Development Review Team (DRT) Comment Form for Planning Commission

Case No.: 2025-11006 Vistas de la Sierra Phase 3 Subdivision

Case No.: Case 2025-11006: Vista de la Sierra Phase 3 Preliminary Subdivision Plat

VISTAS DE LA SIERRA SUBDIVISION - PHASE 3
SANTA FE, NM
TOPOGRAPHIC SURVEY
SHEET 2 OF 2

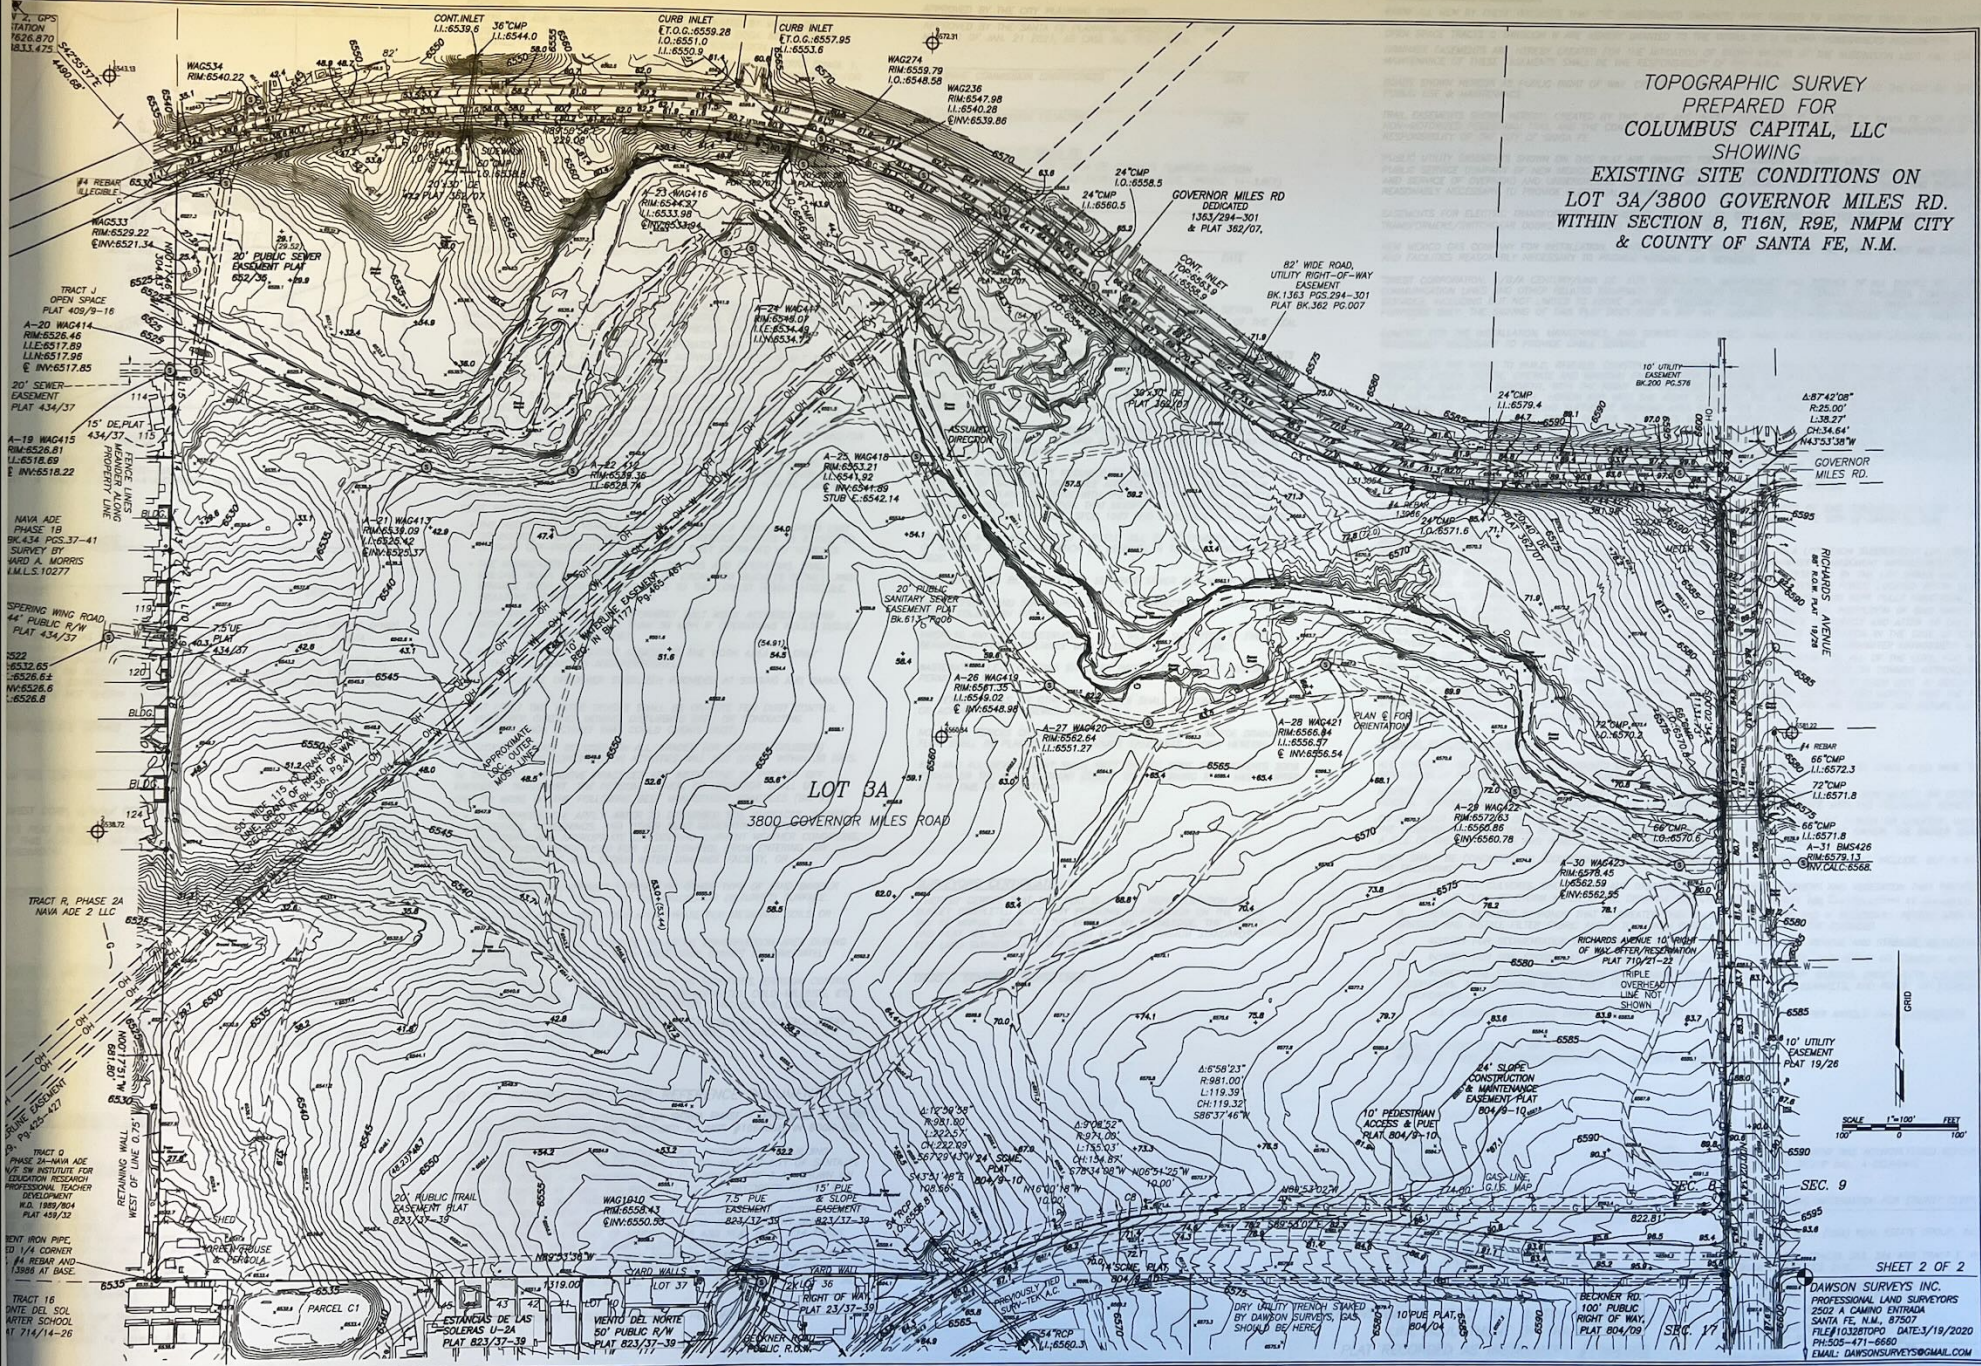
PROVIDE
STAMP.

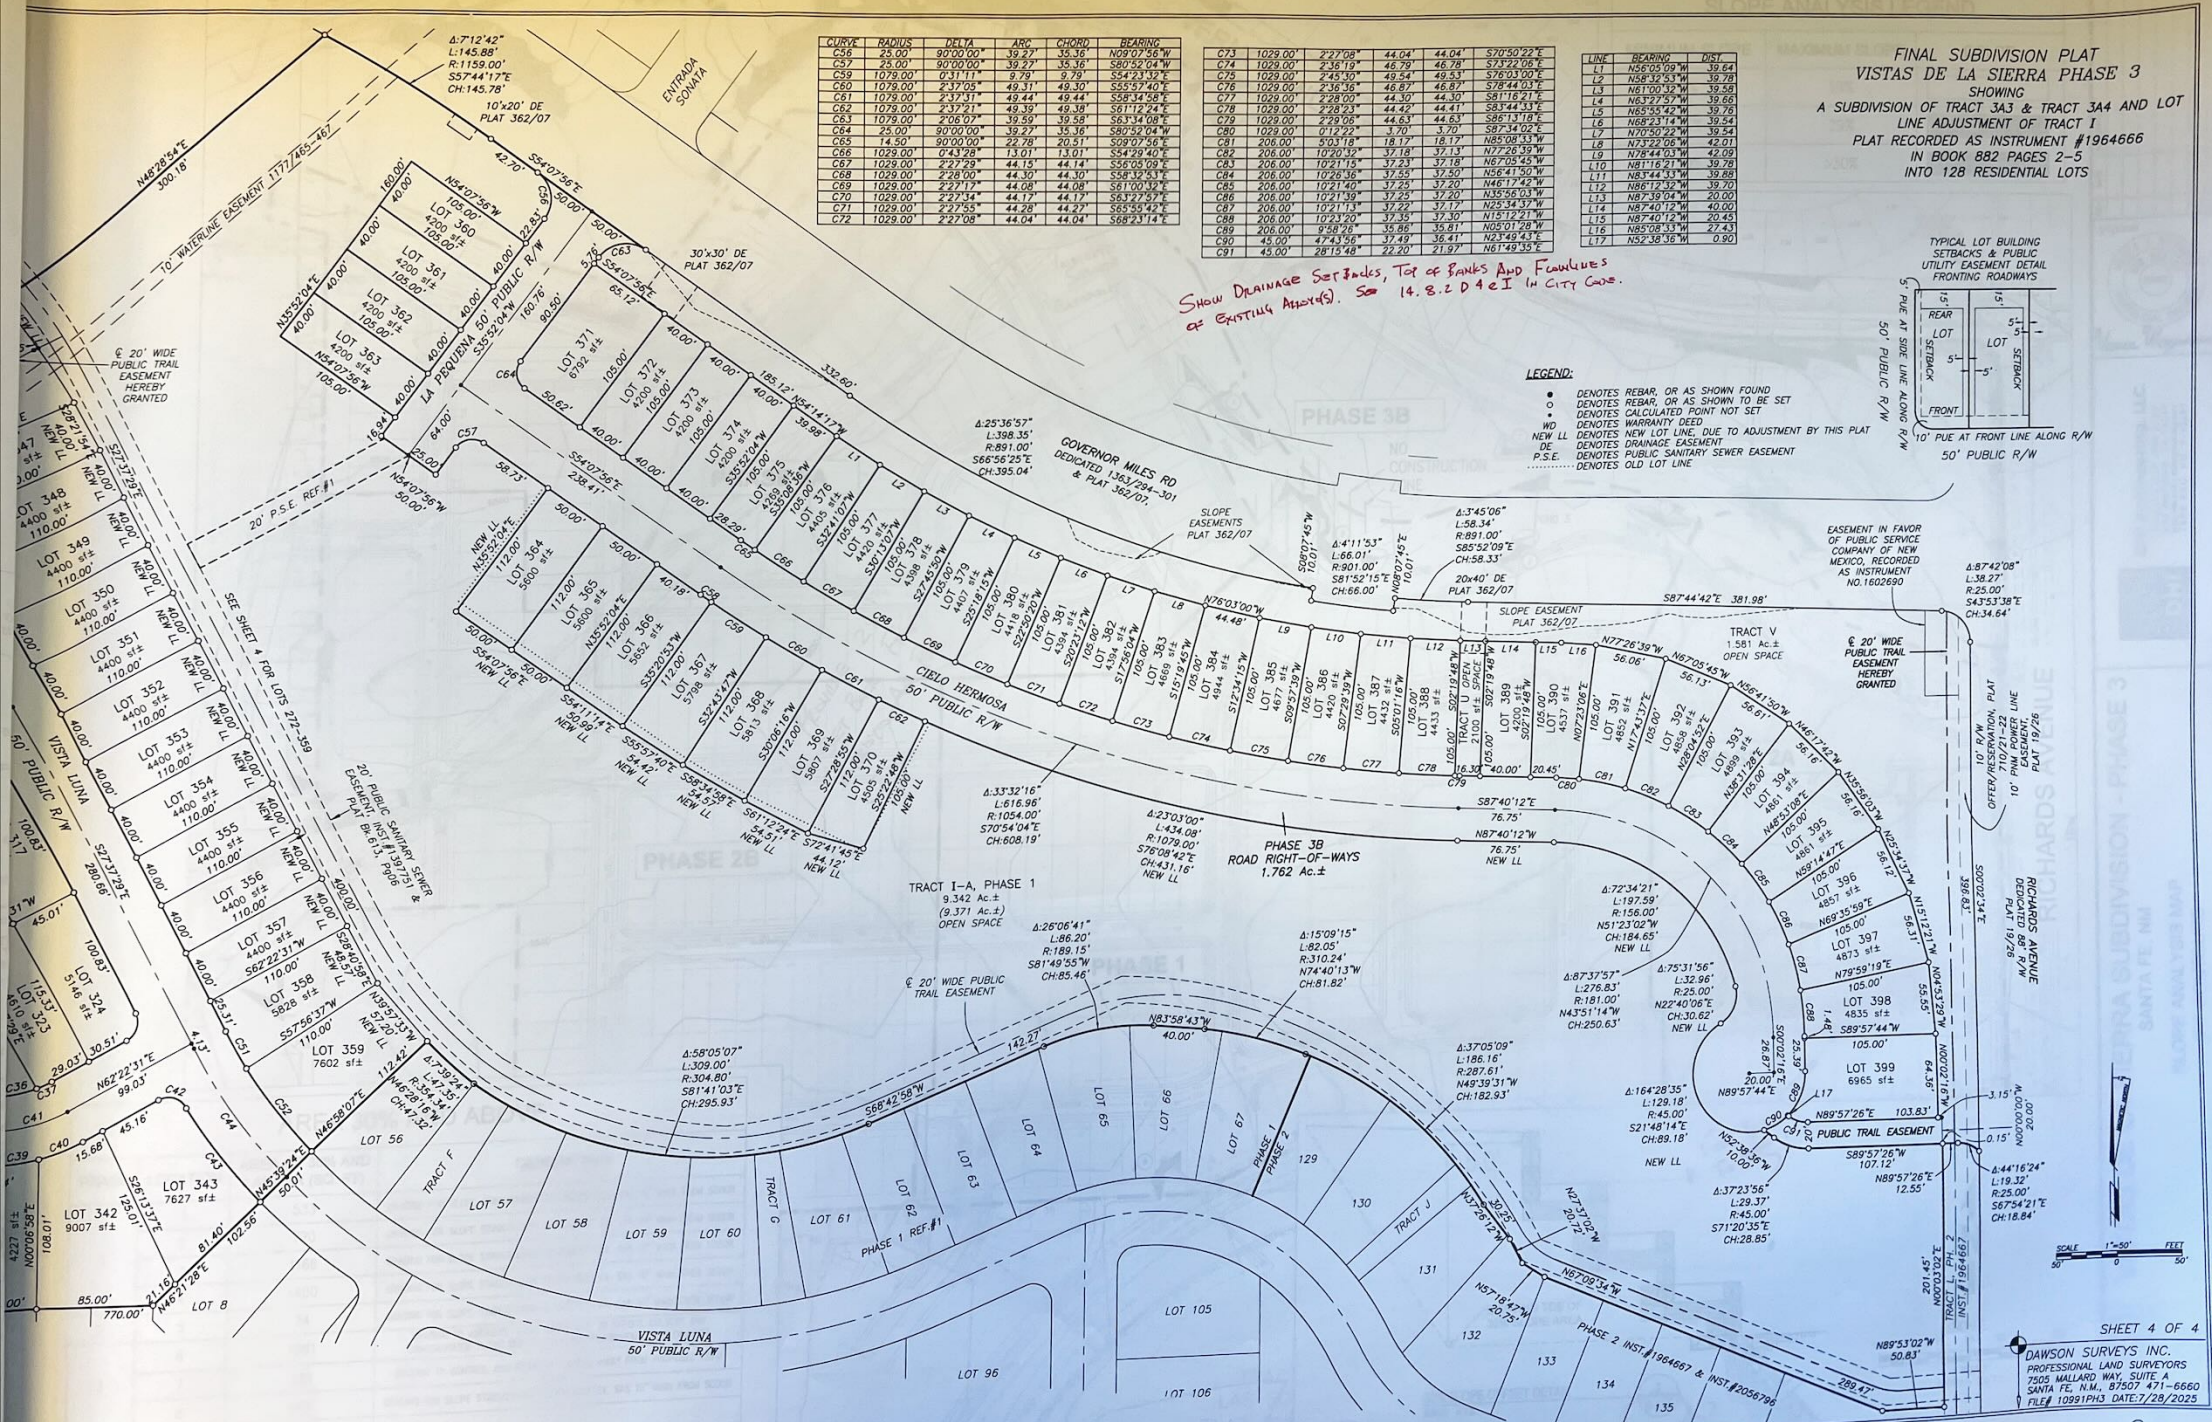
SHOW DRAINAGE SETBACKS, TOP OF BANKS AND FENCE LINES OF EXISTING AREAS. SEE 14.8.2 D & E I IN CITY CODE.

SLOPE ANALYSIS LEGEND		
MINIMUM SLOPE	MAXIMUM SLOPE	COLOR
0%	19%	
20%	29%	
30%	>30%

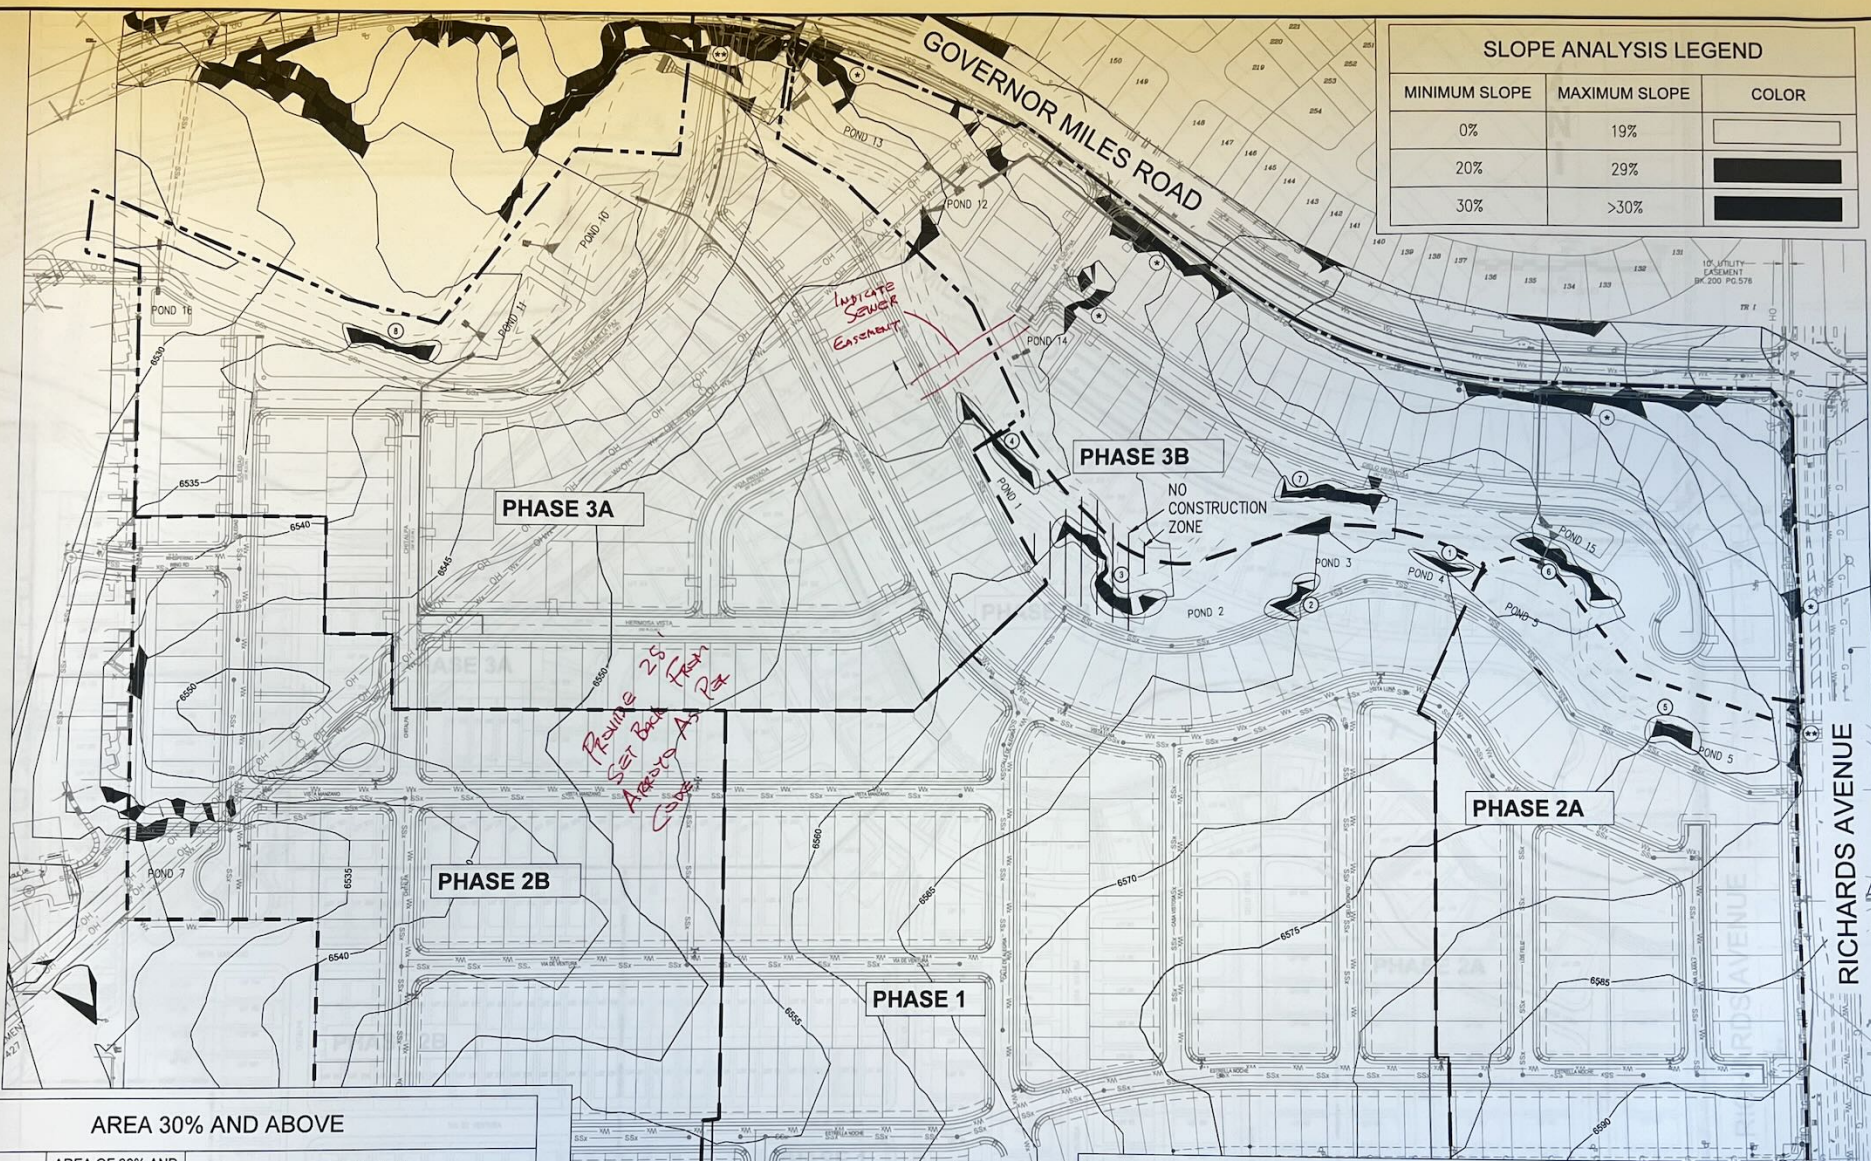
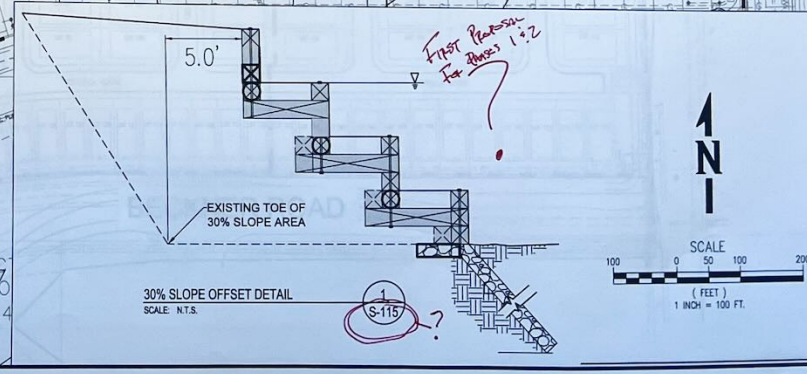
SLOPES/ ARROYO THREATEN GOVERNOR MILES ROAD AND REQUIRE CORRECTIVE ACTIONS PER ANNEXATION AGREEMENT.

SECTION "D-D"

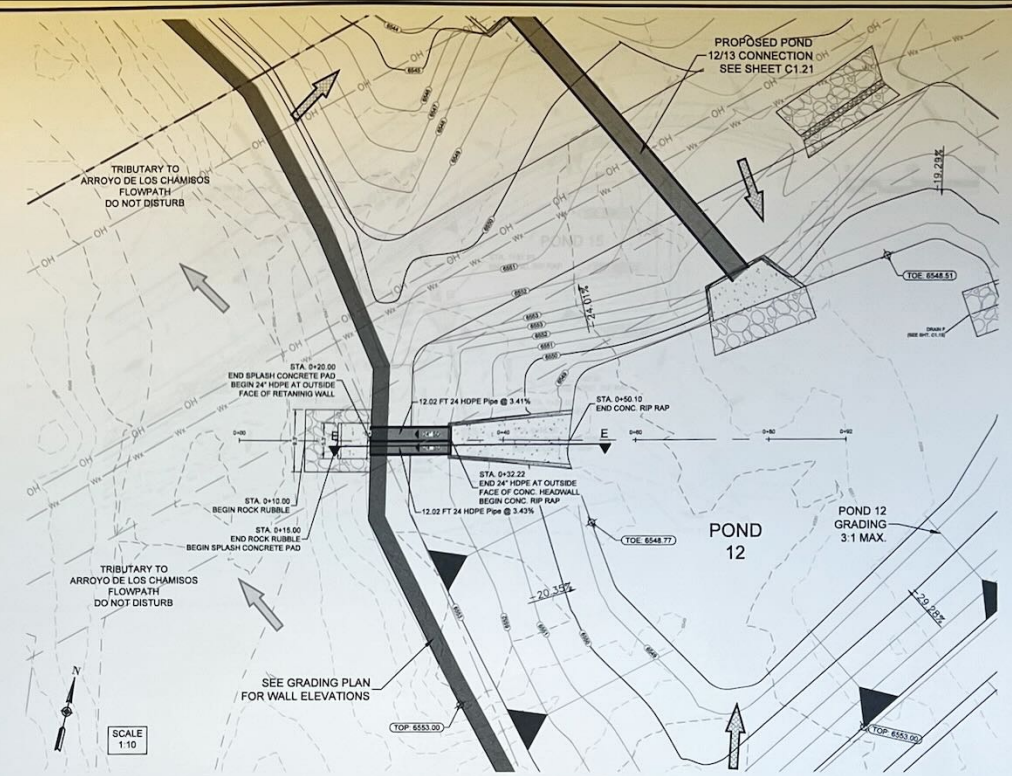
Show Pond Inverts on Plan View

SOLEDAD
STA. 6+78.62 TO 9+58.12

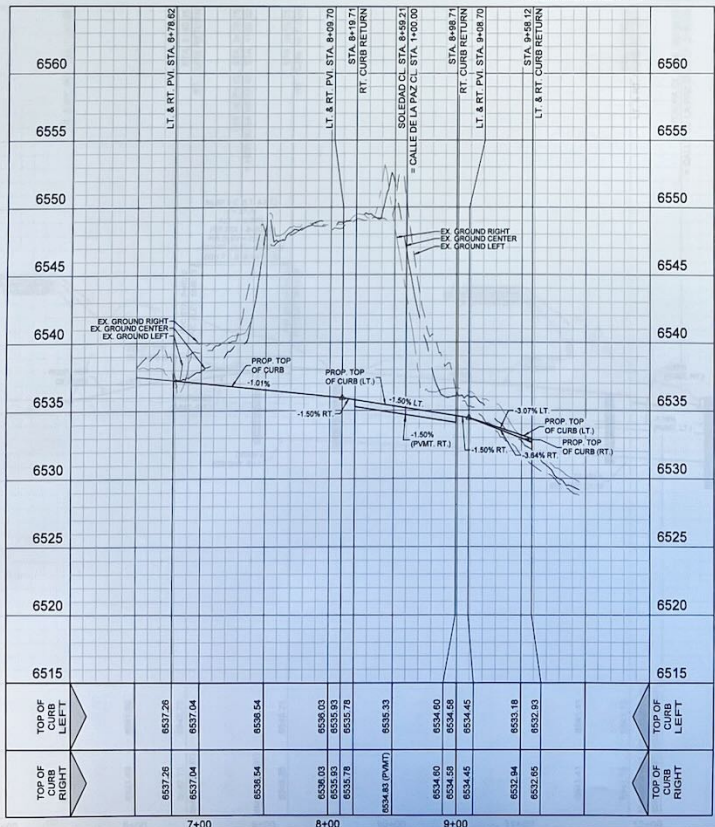
TRANSITION?
City Reviewers Advise
Ramps at Point of Curves 1
Remove Turn on Trac (Ramp)
Will Passways Be Increased?
